165 Williamsons Road, South Morang

Urban Design Advice Memo – include revised landscape approach

Figure 3: Render facing south west towards the building from Findon Road (Ewert Leaf TP DWGS 07.08.2026)

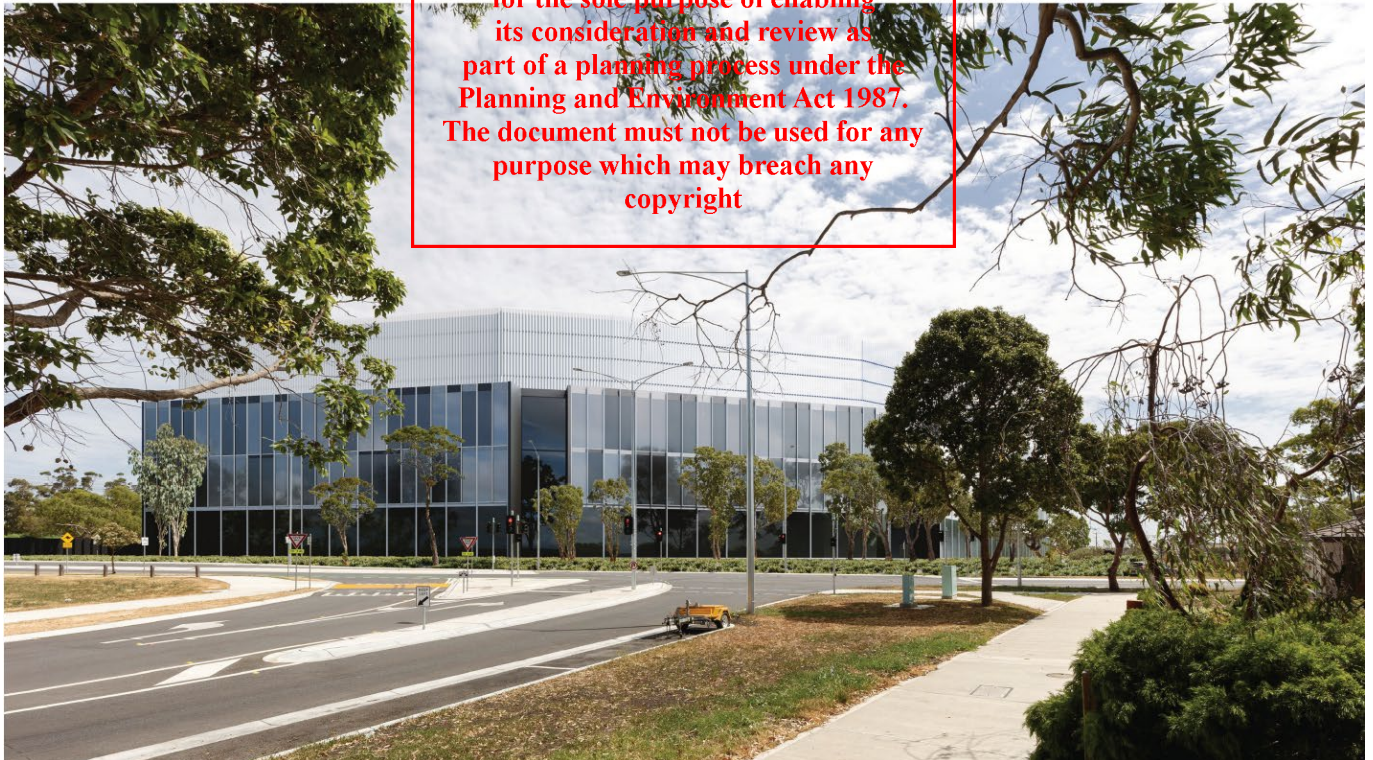
We consider this aspect to successfully 'disguise' the internal use of the data centre. The articulation of the façade is more akin to a large office building and not out of place in the surrounding context, particularly the close neighbours to the north (storage facility), the South Morang Terminal and Substation to the west and the big box land uses to the south.

The existing verge conditions along Findon Road comprise swales, trees, and other vegetation. The Landscape Plan includes recommendations for the Council verge such as canopy tree planting (Blackwoods) with additional screening on the fence (not shown in the render above). This condition will continue to improve as the landscape matures and we consider the relationship between Findon Road, the verge planting, screening planting on the fence and the massing and architecture of the data centre to be appropriate for the location.

Figure 5: Approved plans 130 Williamsons Road, South Morang (Abacus 24.10.2025)

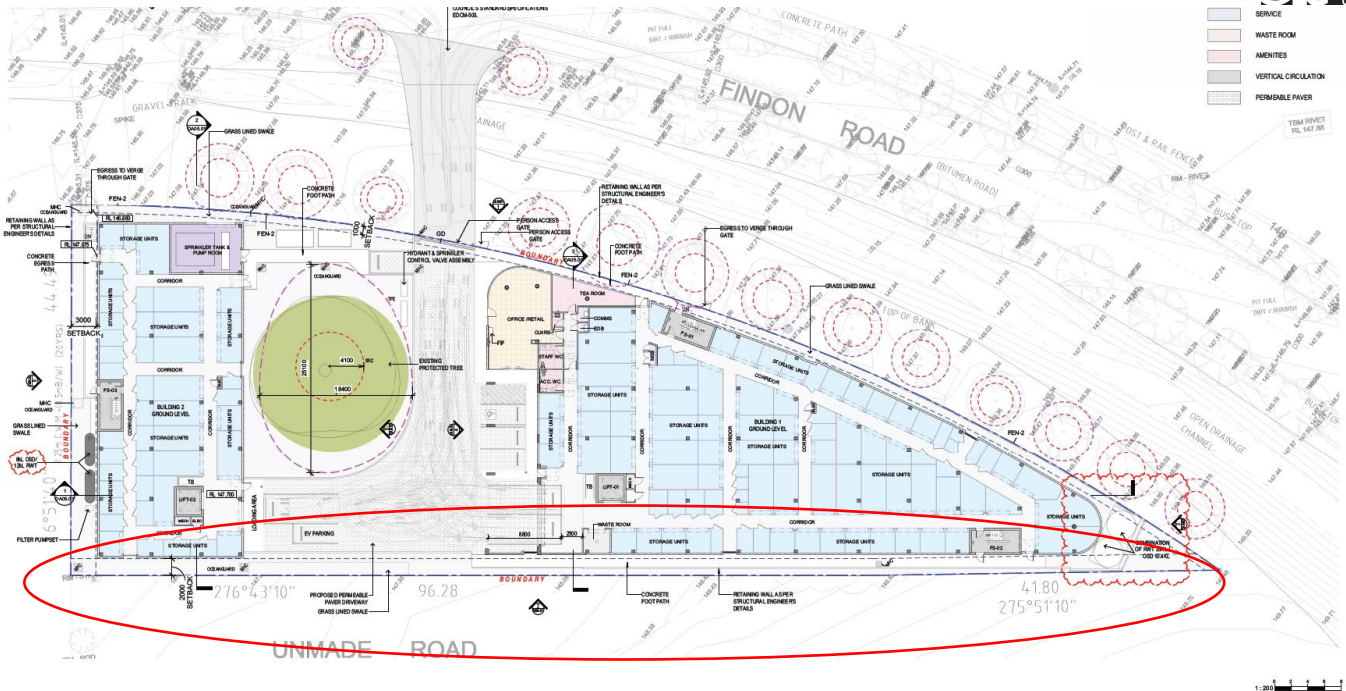
There are also opportunities to enhance landscape buffers and setbacks between the 130 Williamsons Road site to the north and the subject site, across the proposed road extension. We recommend the provision of generous verges on either side of the road to support canopy tree planting where space allows noting that access to the site may be required and this should be considered in the spacing of verge canopy trees.. The approved plans for 130 Williamson Road shown in Figure 5 provide minimal opportunities for canopy planting.

Figure 7: Landscape plan highlighting opportunity for planting within built form cutouts

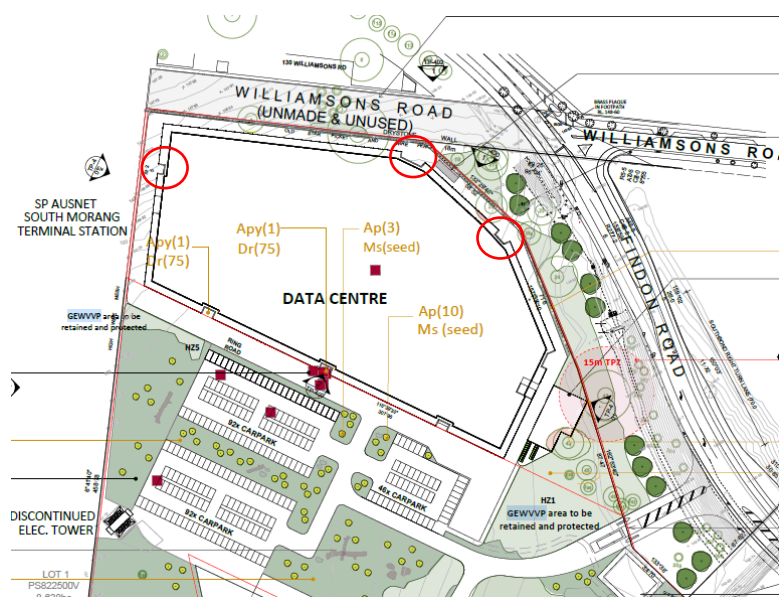
Currently, only two of the five cut-outs along the façade are planted, as shown in the landscape plan below (Figure 7). All cut-outs should be planted to help break up the visual bulk of the development if possible. This approach aligns with the Department of Transport and Planning's principles for reducing building massing and

creating a visually recessive form, including “increased landscaping setbacks from key interfaces to conceal the development.” It also supports the DTP recommendation to “mitigate any potential visual impact resulting from the bulk of data centre structures/buildings.”

Figure 8: Landscape plan highlighting potential "overflow parking" area (in red)

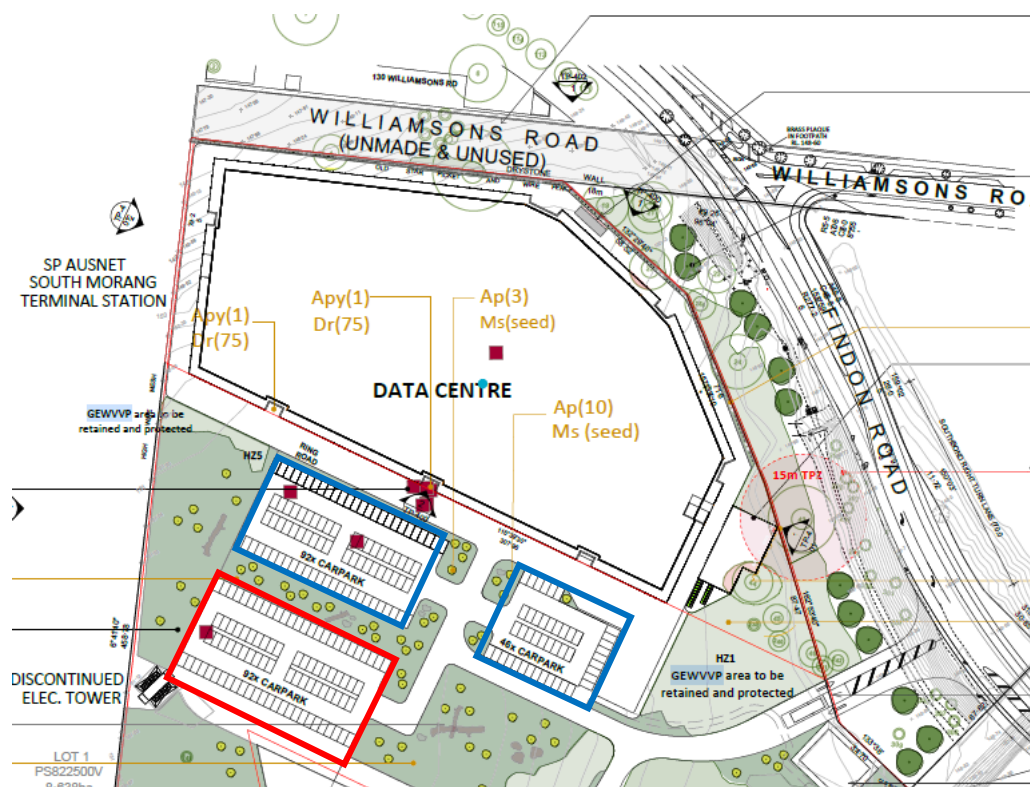
As recommended by DTP, “the central car parking offers opportunity for increased planting on site.” To achieve greater greening across the car park, we recommend that the southern car park be recategorised as “overflow parking,” and that permeable surface treatments be considered (outlined below in red, Figure 8). These measures would support landscaping outcomes and contribute to the site’s Water Sensitive Urban Design. If the size of the car park was reduced at the western end it would enable the retention of the mapped Matted Flax Lily if appropriate.

Landscaping within and immediately surrounding the car park should include shrubs and ground covers to reduce urban heat and provide lower level shade. In the mid-sections of the northern car parks, wider planting areas should be incorporated to accommodate additional vegetation and passive Water Sensitive Urban Design treatments (shown in blue on the landscape plan above, Figure 8).

Figure 9: Façade concept precedent imagery

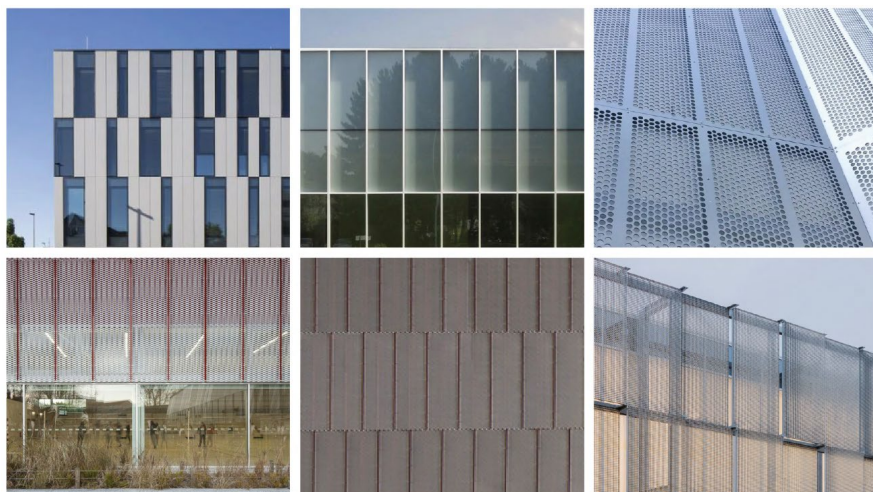
DTP's design principles and recommendations aim to refine the façade to better achieve the broader goals for the built form. For example, the façade can help make the building more visually recessive and break up its massing. We support the principle of refining the design to “create visual interest through a façade strategy.” We consider that the variety of materials and their arrangement achieves the design objectives, in particular the layered approach to the perforated screening which will change through light and shadow throughout the day. The materiality successfully balances the very specific performance requirements of a data centre with a purposeful and considered architectural approach.

We agree with the recommendation to explore greater integration of greenery to further reduce visual bulk noting that this can occur in and around the edges of the building ‘notches’.
